SERVICE BULLETIN

Service Bulletin No.: DA20-79-03 Rev 1

Title: Oil Dipstick, Thermal Insulator

Figure 01 - Oil Dipstick Installation

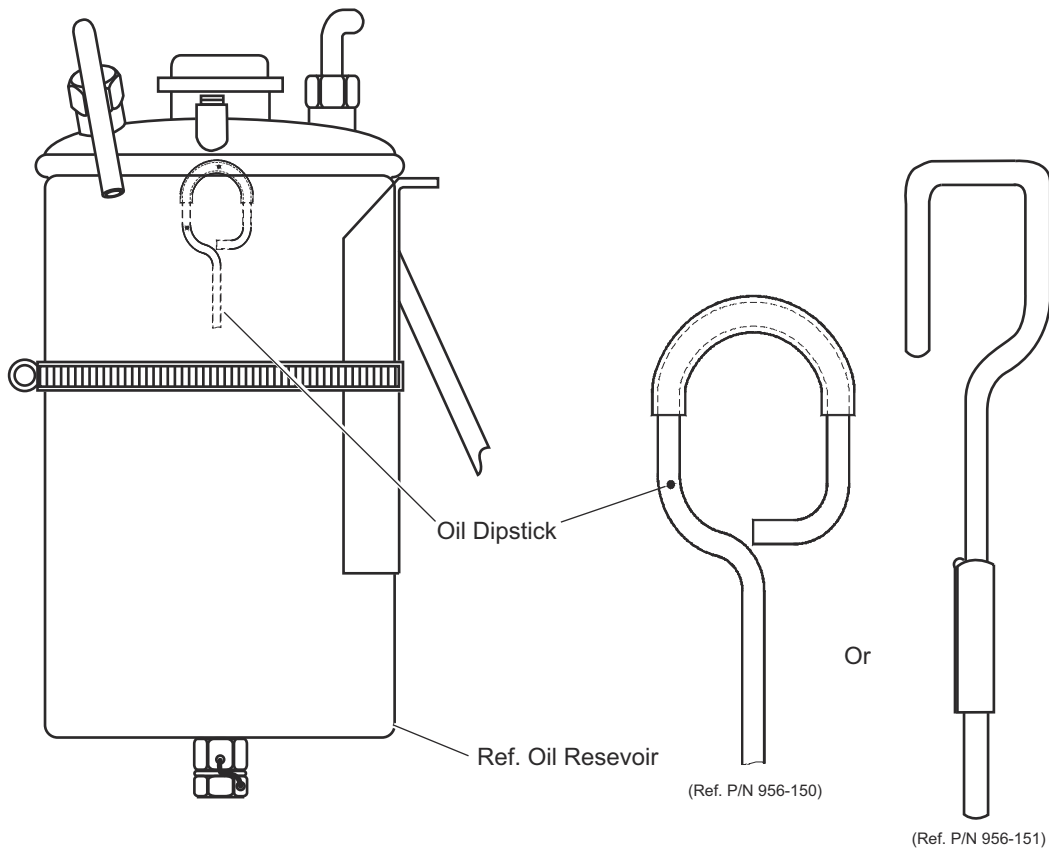
- 1. **ATA Code:** 3310
- 2. **Effectivity:** All DA 20 Katanas, up to and including Serial number 10056.
- 3. **General:** This bulletin describes the installation of a thermal Fluran insulator tube over the handle of the Rotax 912 oil dipstick.
- 4. **Compliance:** Compliance with this Service Bulletin is recommended.
- 5. **Approval:** Engineering data referenced or contained in this service bulletin is approved as part of the type design.
- 6. **Labour:** Approximately 0.30 man-hour will be required to accomplish this Service Bulletin.

- 10.1 Remove the upper cowling from the aircraft.
- 10.2 Remove the oil reservoir cap.
- 10.3 Remove the oil dipstick.
- 10.4 Use a bench vise to open bend, lubricate handle with engine oil and slide Fluran tubing on to distick as shown in Figure 1.
- 10.5 Close bend to its original shape.
- 10.6 Ensure Fluran tube is located evenly on the top of the handle.
- 10.7 Make a log book entry that this Service Bulletin has been incorporated.
